HISTORIC PRESERVATION BOARD STAFF REPORT		
	250 Royal Court	
Meeting	File No.	Application Type
October 15, 2025	HP-117-2025	Certificate of Appropriateness & Level 1 Site Plan
	5-6-1-6-

The item before the Board is consideration of a Certificate of Appropriateness (HP-117-2025) & Level 1 Site Plan application for exterior modifications on a non-contributing commercial structure located at **250 Royal Court, Del-Ida Park Historic District**.

The request before the board is for the removal of the existing wood siding for the installation of smooth stucco siding, installation of white frame aluminum windows (after-the-fact), and repainting of the structure.

# Delray Beach Historic Preservation Design Guidelines - Siding

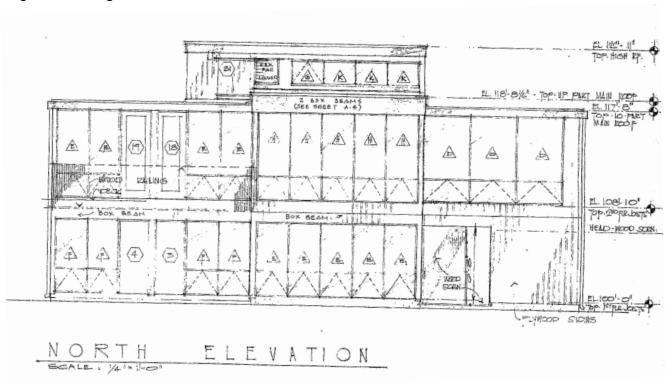
With respect to **Relationship of Materials and Color** the subject proposal consists of the removal of the existing wood siding and application of a new smooth stucco as well as installation of white frame aluminum windows (after the fact). Included with the request is repainting the structure white (awning, columns, trim, and railings). There is no concern with the proposed colors. The Visual Compatibility Standards regarding materials and textures states **that the Relationship of Materials, texture, and color of the facade of a building and/or hardscaping shall be visually compatible with the predominant materials used in the historic buildings and structures within the subject historic district. Rather, the recommended approach is to utilize materials that match <b>the old in design, color, texture, and other visual qualities and, where possible, materials.** As the existing structure currently utilizes plywood siding with a vertical board-and-batten design, the appropriate replacement is to match. The Delray Beach Historic Preservation Design Guidelines do not recommend creating a false architectural appearance by adding or eliminating details. The difference in appearance the smooth stucco will create compared to the vertical siding will permanently alter the exterior of the structure and remove original character defining features.

Staff previously approved a COA to paint the window frames, building trim, and railings a navy-blue color (Sherwin Williams "Naval"). The windows at the time had dark red frames. The approved blue color was seen as appropriate as it retained the dark color painted frames allowing for a modern update to the windows. With the new proposal, the windows are to be white frame aluminum. There is concern with the color, as the structure had retained dark red frames and are believed to have been original to the structure, as far as staff could substantiate through photographs, which should be maintained. Additionally, it was not uncommon for this style of structure to have color window frames and would be most appropriate given the previous frames were already painted. There is also concern with the appearance/style of windows. The original building permit shows a muntin for each window, which had been retained over the years, and should be replaced like-in-kind to maintain the appearance, where the proposal is to utilize a single pane. As previously mentioned, this structure is non-contributing however, inappropriate modifications via removal of original Contemporary/Mid-century character defining features could impact the structure's potential historic integrity.
